Applicant: Joel Livingood; Interlachen Country Club
Consultant: Lindsey Roberts McKenzie; SEH, Inc.
Project: Interlachen Country Club Golf Course Renovation
Location: 6200 Interlachen Boulevard, Edina, MN
Applicable Rule(s): 2, 3, 4, 5, 6, 10, 11 and 12
Reviewer(s): Louise Heffernan; Barr Engineering Co.

Background

The applicant is proposing the renovation of the Interlachen Country Club golf course located at 6200 Interlachen Boulevard in Edina. The project will include grading, conversion of the turf grass from primarily Kentucky bluegrass to bent grass, tee box and green improvements, fairway modifications, utility improvements, golf cart path renovations, landscaping and site improvements. The existing fairway alignments are proposed to remain.

Figure 3. Proposed drainpipe locations (shown in red).

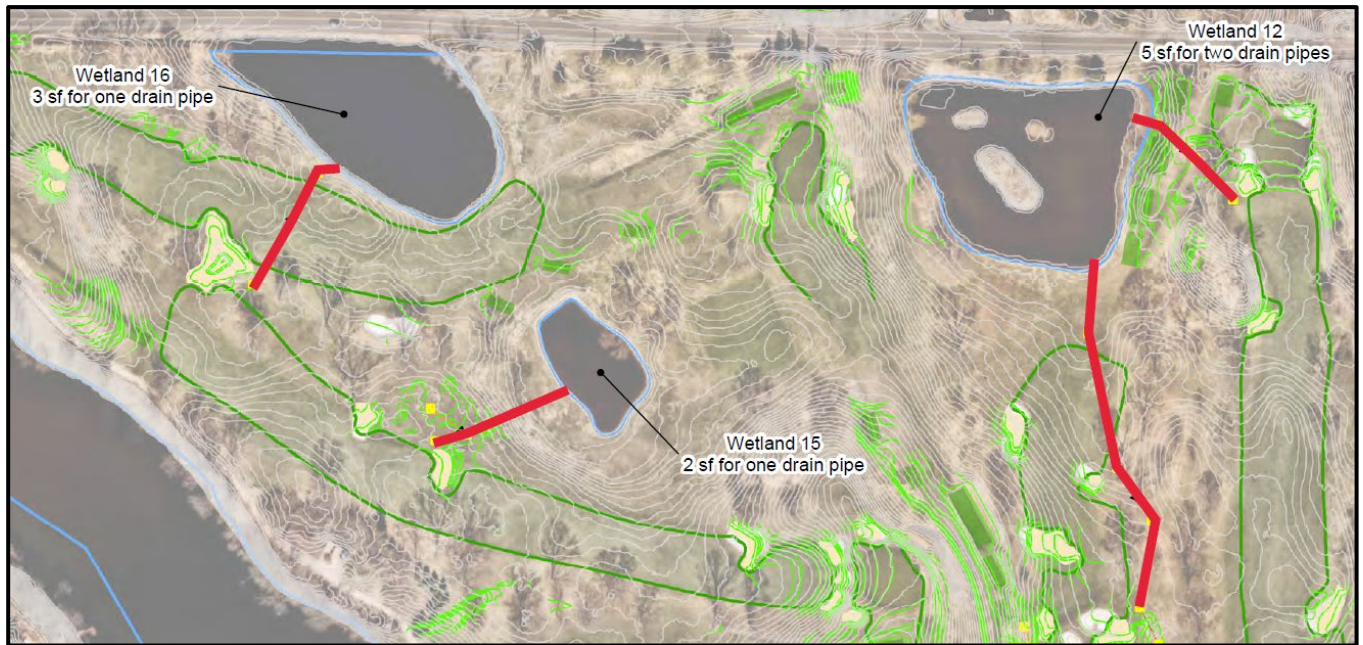
New 6-inch and 12-inch drainpipe is proposed to be installed in the bank or bed of Wetlands 12, 15 and 16 for the purpose of conveying stormwater runoff from depressions within the wetlands' drainage area boundaries.

Because impervious areas are not proposed to be increased within the site, subwatershed drainage areas or boundaries are not to be altered, an increase in additional stormwater runoff volume will not be generated (impervious area reduced), discharge rates from the site will be maintained and or reduced, and flood storage volume below the 100-year frequency flood elevation for each wetland will be maintained, the engineer finds that the installation of the drainpipes will not result in hydraulic capacity modifications or increases in the flood stage of the wetlands. The materials demonstrate and the engineer finds that the project is in conformance with subsection 6.3.1a criteria.

FIGURE 7
Wetland 16 - Wetland Buffer Details

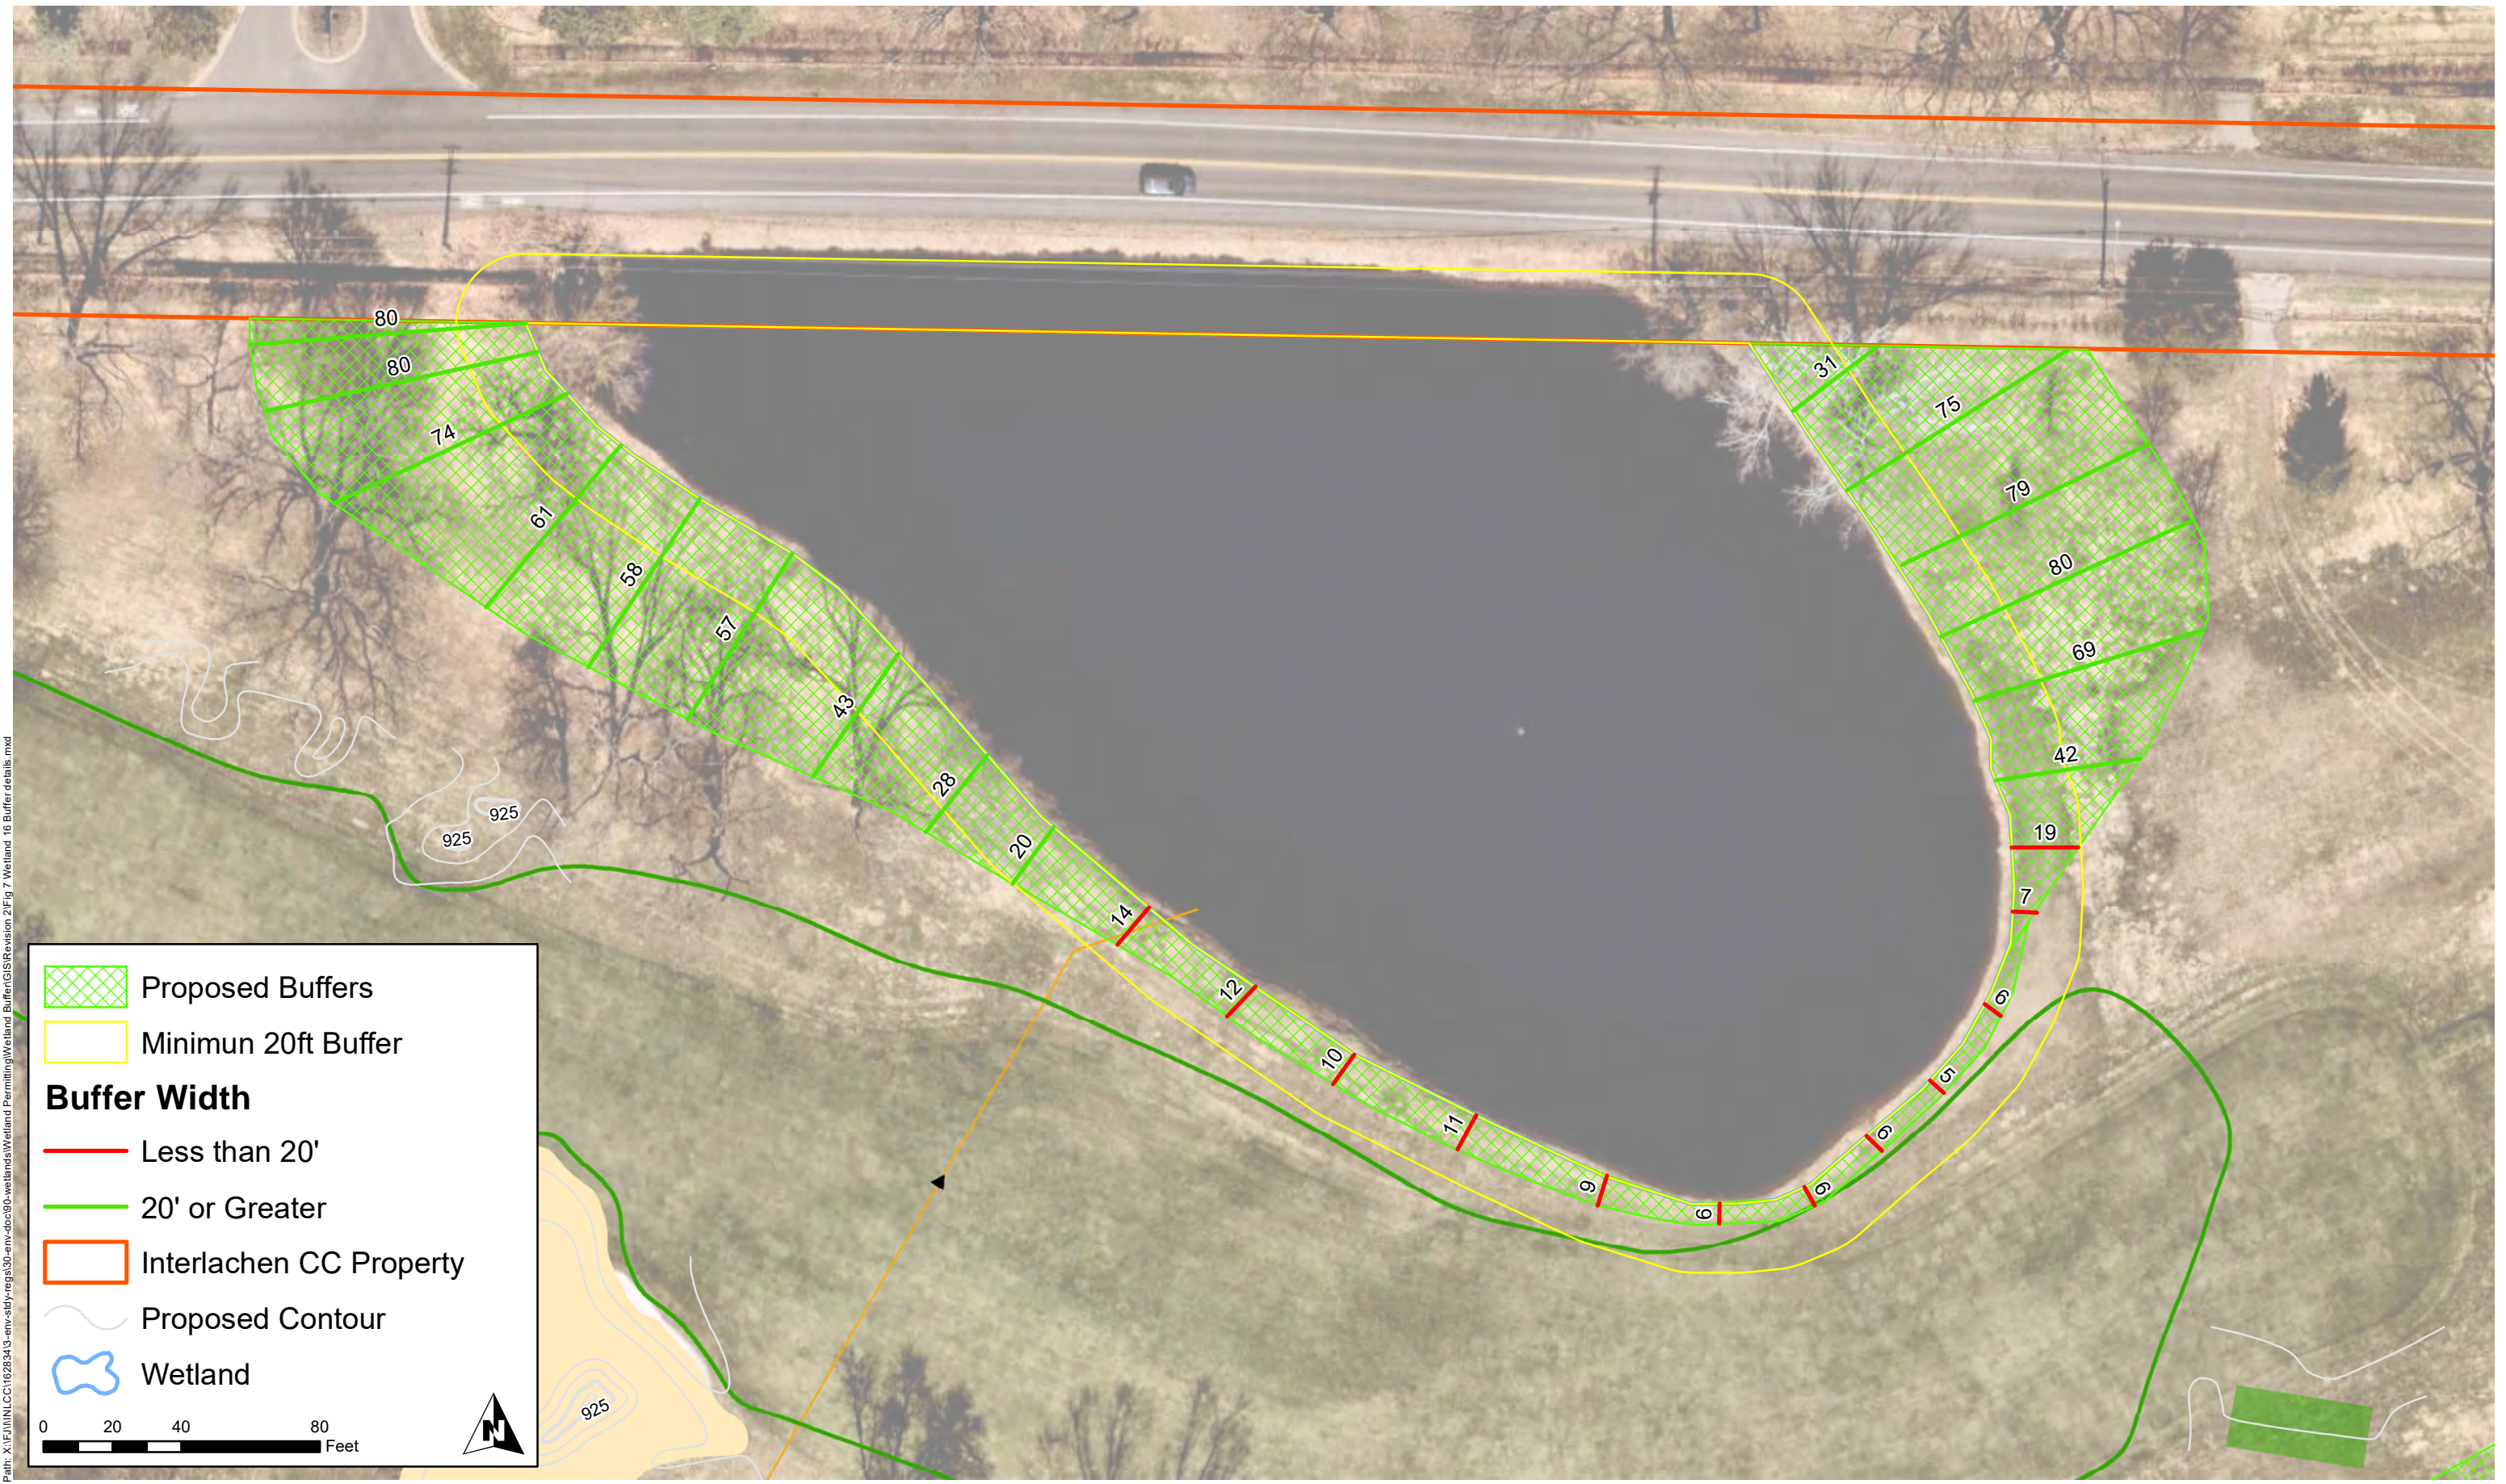
- **Wetland 16:** The minimum buffer width provided is 5 feet, which represents a 75% shortfall from the requirement. The minimum buffer shortfall occurs along the southern wetland boundary, where proposed buffer widths range from approximately 5-19 feet, for approximately 340 feet (45.2%) of the wetland boundary. The minimum buffer width shortfall results in an overall average buffer area shortfall. The required buffer area, based on the required 40-foot average, is 32,517 square feet. The proposed buffer area is 27,541 square feet, which represents a 4,976 square foot (15.3%) shortfall from the requirement.

- The NMCWD engineer finds that the minimum and average requirement shortfalls, located along the southern portion of Wetland 16, present water quality degradation risk in comparison to the establishment of the required buffer area. The Wetland 16 shortfall is primarily due to the existing fairway location within the required buffer area. The plans indicate that zero impervious area is tributary to Wetland 12, and the pervious surface tributary to the noncompliant buffer area includes a gentle slope (approximately 5%). The plans also indicate that the existing and proposed drainpipe will collect stormwater runoff from the depressions throughout the Wetland 12 drainage area, thereby reducing concentrated flow down the wetland bank along the southern edge. Because no impervious surface is tributary to the noncompliant buffer area, discharge rates will be maintained, concentrated flow across the bank will be reduced resulting in low erosion potential, drainage boundaries will not be altered, and flood risk will not be increased (see subsection 2.3.1), the engineer finds that the shortfalls in buffer are not likely to present significant risk or likely to significantly degrade the resource or change the character of the resource.

- The submittal notes, at Wetland 16, the existing fairway alignment prevents the establishment of the required minimum buffer. No grading is proposed along the noncompliant southern portion of Wetland 16, and the applicant asserts that the establishment of the minimum width at Wetland 16 requires fairway redesign.
